Re: Request for review of the request for issuance for the CDM project activity "BOG and COG Utilization for Combined Cycle Power CDM Project in Jinan Iron & Steel Works" (Ref. no. 0812)

1) The DOE is requested to provide further information on how it verified that PP has deducted consumption of electricity by the auxiliary equipments of the project activity while calculating the net electricity supplied by the project activity

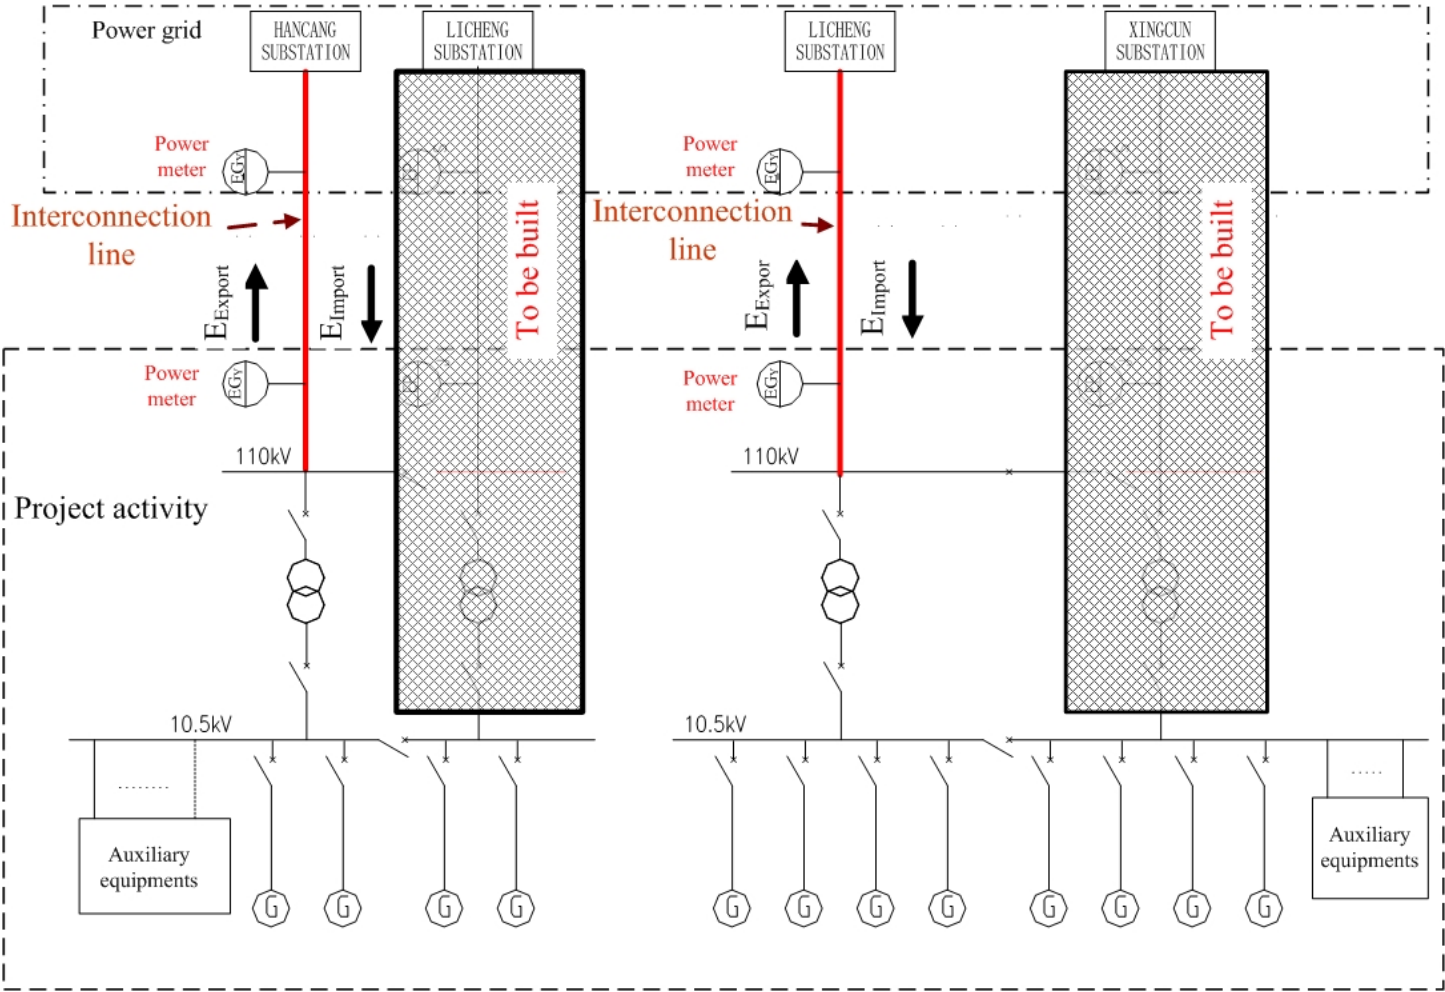
2) The number of credits claimed is lower than indicated in the PDD. PP is requested to clarify why the PLF is lower than assumed in the PDD, thereby also explaining whether higher PLFs than the PDD could have been applicable as well.

- The capacity of the interconnection line for phase II restrict the operation of the generation units
- Technical barriers as described in PDD affect the performance of the project activity.

There are two interconnection lines designed to connect phase II with the power grid, but only one line was built. As the capacity of this interconnection line is not enough for transmitting all the electricity generated by phase II, some of the generation units could not be put into operation.

The project owner is building the second interconnection line, and it is expected to be put into operation in a few months.

The project activity is not a traditional natural gas fired CCPP (combined cycle power plant). As the project is one of the first applications of using waste BOG and COG to generate power in combined cycle configuration, there are quite a few technical barriers to it (please refer to PDD for detail). As a matter of fact, the project activity did experience all the technical barriers described in the PDD. As a result of this and also due to limitation of waste gas, the Power Load Factors (PLFs) are lower than assumed in the PDD and thus result in the number of credits claimed lower than indicated in the PDD
